City of El Paso - City Plan Commission Staff Report

Case No: SUSU12-00055 Sandstone Ranch Unit Seven Replat D

Application Type: Resubdivision Combination

CPC Hearing Date: June 28, 2012

Sandstone Ranch Unit 7 Replat D

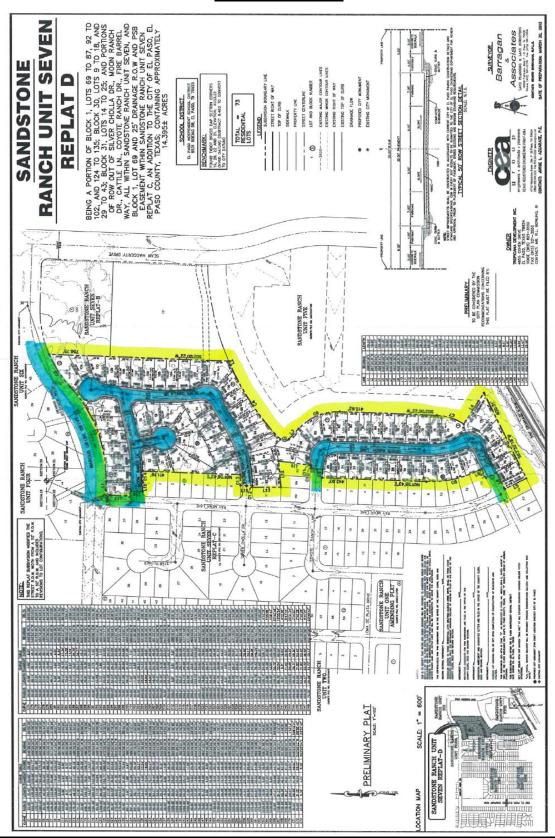
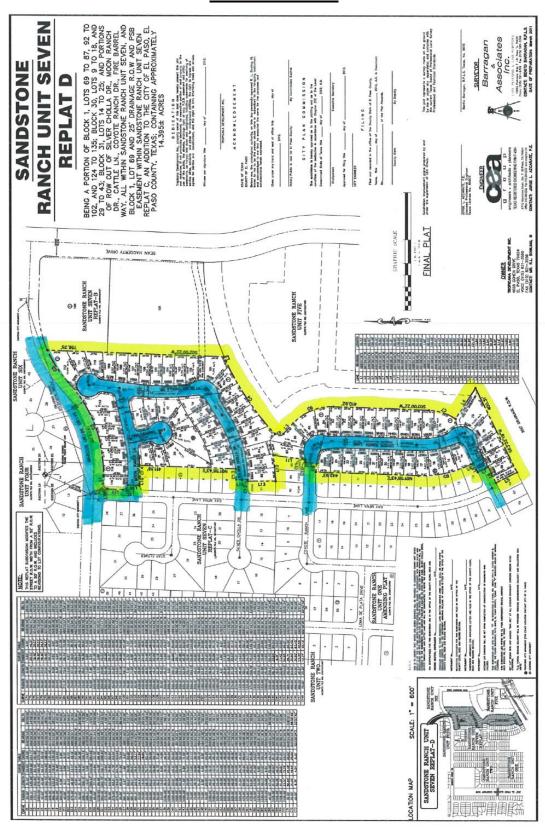
- Modification for a 110' turning heel
- Modification for a 50-foot ROW with a five foot sidewalk, four foot parkway, and 32' of pavement

• Sandstone Ranch Unit Seven Replat C shall be recorded prior to the proposed subdivision in order to provide access to Moon Ranch, Silver Cholla, Cattle, and Coyote Ranch

Staff is recommending that the City Plan Commission require the applicant to landscape the parkway at the rear of all double frontage lots, as stipulated under Section 19.16.080.D of the previous subdivision code. The city plan commission may require that a parkway at the rear of a double frontage lot be landscaped or other aesthetic treatment be provided by the subdivider, subject to the approval of the development services director or designee, to provide a visual separation between the development and the street. Staff also recommends that if the City Plan Commission requires landscaping, that the condition be coordinated with the El Paso Department of Transportation where it conflicts with site visibility standards, utilities, and parkway illumination. For the type of landscaping, staff recommends the developer select trees designated as median/street/right of way appropriate from the City's Plant and Tree List, to be placed 30-feet on centers.

- 1. Double frontage lots along Marcus Uribe shall comply with Section 19.23.040 H (Double Frontage Lots).
- 2. Sandstone Ranch Unit Seven Replat C shall be recorded prior to the proposed subdivision in order to provide access to Moon Ranch, Silver Cholla, Cattle, and Coyote Ranch

- 1. EPWU-PSB does not object to this request.
- 2. The area is located within an intermediate pressure zone off the War Highway Pressure Zone. Private water pressure regulating devices will be required at the discharge side of each water meter. The Owner/Developer shall include in the sale of contract documents that the lot/home buyer shall acquire ownership of the above-described water pressure regulating devices to be located at the discharge side of the water meters. Additionally, the lot/home buyer shall be responsible for the operation and maintenance of the above-described privately-owned water pressure regulating devices.

- 3. Water and sewer service for the subdivision requires extensions from the water and sewer mains within Sandstone Ranch Unit 7 Replat C which are currently under construction. There is an existing 8-inch diameter water main that extends along the existing 30-foot wide PSB easement and continues along the existing 15-foot wide PSB easement within Lot 73, Block 1. Sewer service for the northern portion of the subdivision requires extending a sewer main thru the 25-feet Drainage ROW and PSB easement adjacent to Lot 101, Block 1 to connect to an existing 8-inch sewer main located within Sandstone Ranch Unit 7 Replat B.

- 4. No building, reservoir, structure or other improvement, other than asphaltic paving (HMAC), shall be constructed or maintained on the above referenced El Paso Water Utilities Public Service Board Easements (EPWU-PSB easements) without the written consent of EPWU-PSB. The PSB easement shall be improved to allow the operation of EPWU maintenance vehicles.

The Development Coordinating Committee recommends **approval** of modifications requested based on reason 3 of 19.04.170.A.3 of the previous subdivision code and **approval** of Sandstone Ranch Unit Seven Replat D on a Resubdivision Combination basis subject to the following condition and comments:

Planning recommends **approval** of the modifications and **approval** of the Sandstone Ranch Unit Seven Replat D with a condition. The subdivider has demonstrated an alternative method of development that will improve the aesthetic value of the subdivision while giving equal emphasis to safety, vehicular access and pedestrian passage.
